March 24, 2005

This service bulletin is for the Polyurethane & Polyurea product line(s).

The digital Watlow 935 series controller

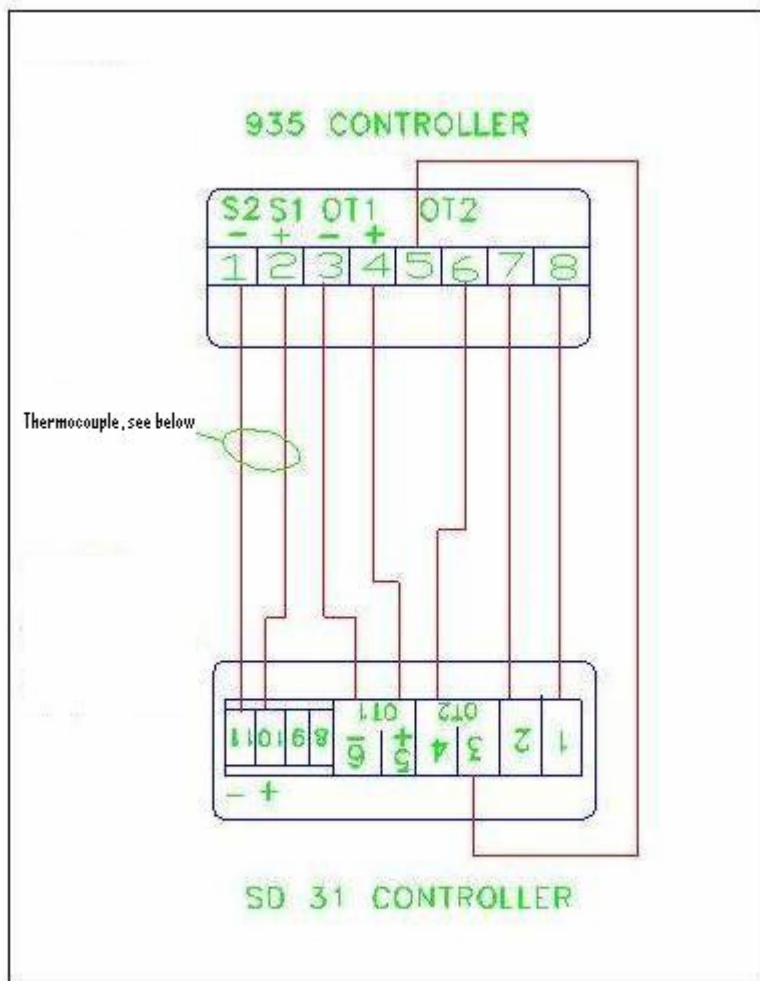
While the physical size of this unit remains the same, do note replacing a 21356-01 with a 21356-02 in a system requires a minor change in the wiring which is detailed in this service bulletin.

The #21356-00 & -01 required holding the "set" button while adjusting temperature set point.

The #21356-02 only requires holding the "up" or "down" button when adjusting temp, the "set" button continues to be the actual/set temp display. The "Infinity" button is inactive for this program.

J T/C T T/C
 (+) WHT. (+) BLUE.
 (-) BLK. (-) RED.
